TB1137

SERVICE INFO

LuK Part Nr: 631 0314 09 – 310/310mm XGW6

New design / Neues Design / Nouvelle conception / Nuevo diseño / Nuovo disegno

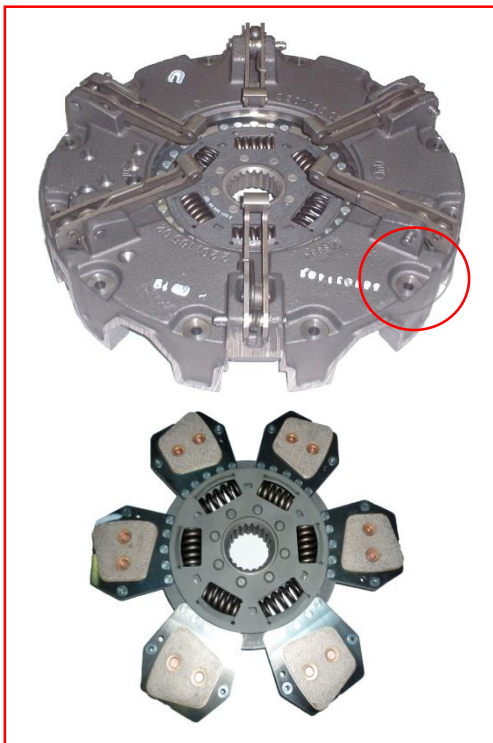
This new design utilises the latest clutch technology, using a vented housing for improved cooling and heat dispersal.

Fully interchangeable with existing clutches with no modifications required to vehicle or flywheel. A new fixation bolt set 12 x M8 x 1.25 x 65mm is supplied with new designs to accommodate the lower housing.

Repset: **631 0314 09 = 231 0039 10 + 331 0117 10 + Bolts: 12 x M8 x 1.25 x 65mm**
